Riverslea Subdivision (Sussex Locations 9002 and 9101), Margaret River

Greendene Development Corporation Pty Ltd

Report and recommendations of the Environmental Protection Authority

Environmental Protection Authority Perth, Western Australia Bulletin 1224 July 2006

Figure 2: Proposal Location and environmental considerations

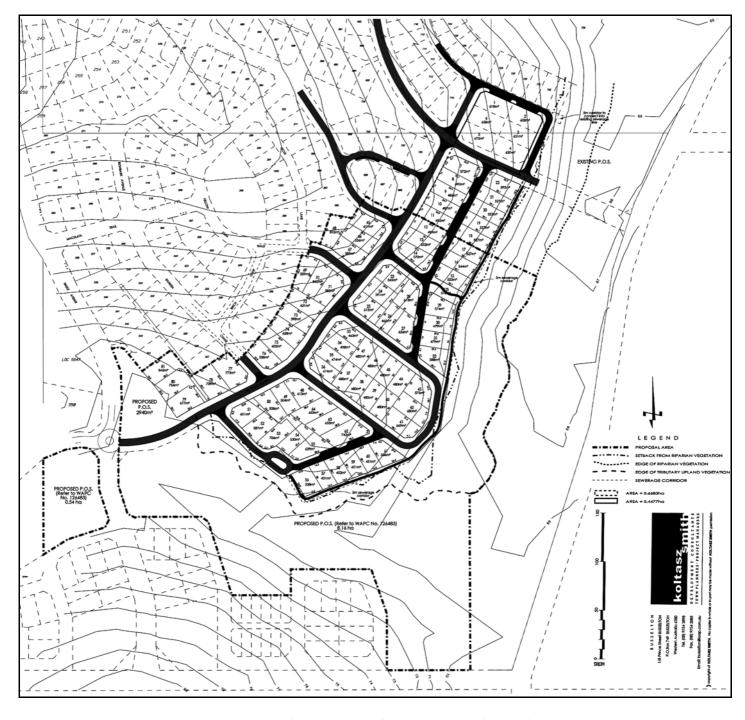
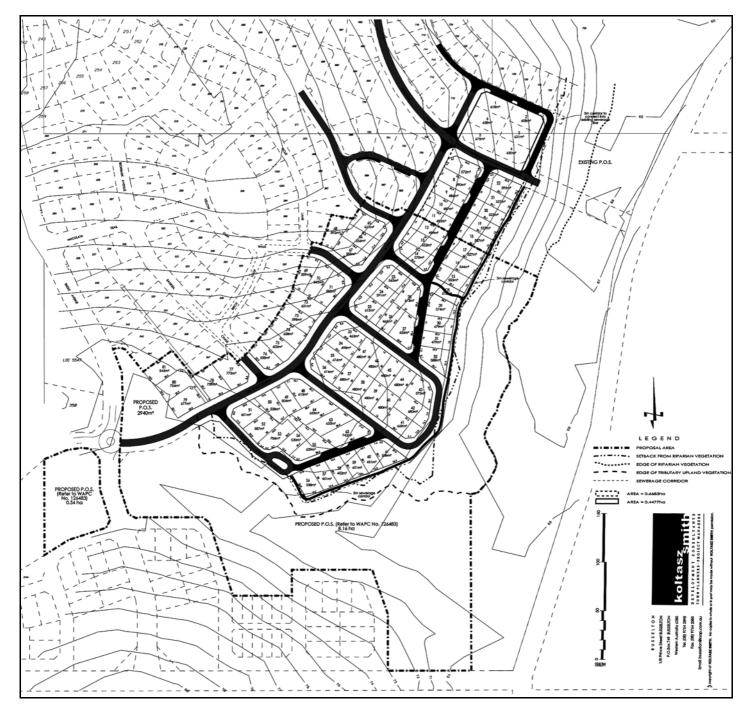
Following receipt of the public submissions and discussions with the EPA, the proponent submitted a revised proposal that provides a 50 metre upland buffer between the edge of Darch Brook riparian vegetation and the proposed subdivision. With regard to the tributary to Darch Brook, the revised proposal provides a set back of at least 15 metres between upland vegetation to the north of the tributary and the proposed subdivision (Figure 2).

It is noted that the proponent has not included other uncleared land to the north of the subdivision (that it also owns) in its current proposal. The proponent does not have environmental, nor planning approval for the 0.67 ha area of vegetation immediately to the north of the proposed subdivision (Figure 2).

The EPA supports the revised proposal, which provides an increased set back from the watercourses, as the subdivision is considered an intensive development, which will result in increased pressure on the riparian zone. Available information indicates that Darch Brook is degrading as a result of land use pressures and development. The upland vegetation, including its understorey, will provide a buffer to the riparian zone from pressures of human activity and the introduction of weeds. The retention of a wider buffer increases the confidence that the overall integrity of this section of Darch Brook and downstream can be held at existing levels.

In order to encompass a holistic approach to development adjacent to Darch Brook it is recommended that the foreshore reserve be extended north, to the intersection of the previously constructed subdivision.
